Wildwood Medical Center, Local Map Amendment H-117

Completed: 2/6/17

Description

Summary

Figure 6: Simplified Floating Zone Plan

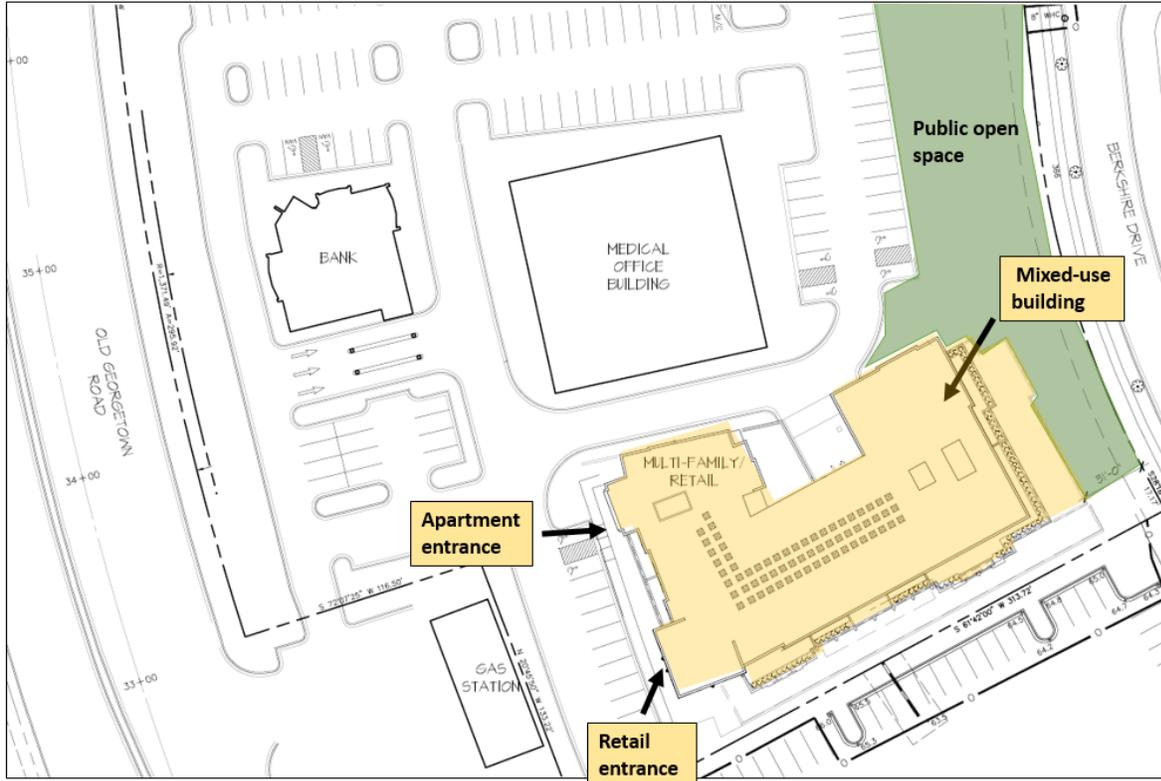
The height and massing of the proposed building are of particular concern in terms of compatibility. The building height proposed in this Application (58 feet) has increased from the previously approved building height of 50 feet, which was a binding element of the prior approval. The proposed 58-foot building will be significantly taller than the houses in the adjacent neighborhood. Further, the point at which building height will be measured (average finished grade along the front of the building) is nearly 10 feet higher than the adjacent residential neighborhood. The perceived building height from the neighborhood will be significantly taller than the measured height of 58 feet.

A binding element connected with the SDPA 12-1 approval required that the building be setback a minimum of 60 feet from the Berkshire Drive right-of-way, and the setback has been reduced to 31 feet in this Application. Although the east (neighborhood) side of the proposed building steps down, the proposed building reaches its tallest point within 60 feet of the Berkshire Drive right-of-way, which brings the building mass too close to the neighborhood. The massing and setback of the building approved in 2013 were significantly more compatible with the adjacent neighborhood than the building proposed in this Application. The County Council approval of SDPA 12-1 established that a 50-foot building, set back 60 feet from the Berkshire Drive right-of-way, was compatible, and Staff does not find that a 58-foot high building set back 31 feet from the same right-of-way is now compatible, absent any major changes in the area. Staff does not believe that the public interest would be served by approving a building that is significantly less compatible with the neighborhood while offering no additional benefits to the community.

This proposal also does not include trees planted in containers on the rooftops to screen views of the building from the adjacent neighborhood as agreed to in SDPA 12-1. The proposed increase in height combined with the decreased setback and the lack of container trees to screen the upper stories result in a building that is not compatible with the adjacent residential development.

1. The maximum building height is 50 feet.
2. The overall mass of the building must not appear to be more than five stories tall facing east, and it must taper down from five stories to three stories.

3. The building massing along Berkshire Drive must be limited to a maximum height of three stories, or 35 feet, within 50 feet of the Berkshire Drive right-of-way.

Figure 10: North Elevation (facing medical office building)

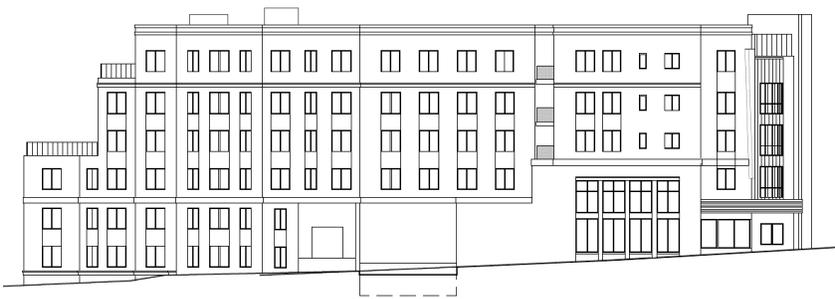
The Property falls within the boundary of the Approved and Adopted 1992 *North Bethesda/Garett Park Master Plan* (North Bethesda Plan) and within the area of the pending *Rock Spring Master Plan* (Rock Spring Plan). Although there are no specific recommendations in the North Bethesda Plan for the Property, the first land use objective of the Plan is, “to protect and reinforce the integrity of existing residential neighborhoods” (p.33). The Property is located on the edge of an existing single-family residential neighborhood, and the height and location of the proposed building are important factors in maintaining the integrity of that neighborhood. The proposed 58-foot building will be significantly taller than the houses in the adjacent neighborhood. Further, the point at which building height will be measured (average finished grade along the front of the building, or 373.4 feet) is nearly 10 feet higher than Berkshire Drive (grade of 364 feet). The perceived building height from Berkshire Drive will be significantly taller than the measured height of 58 feet.
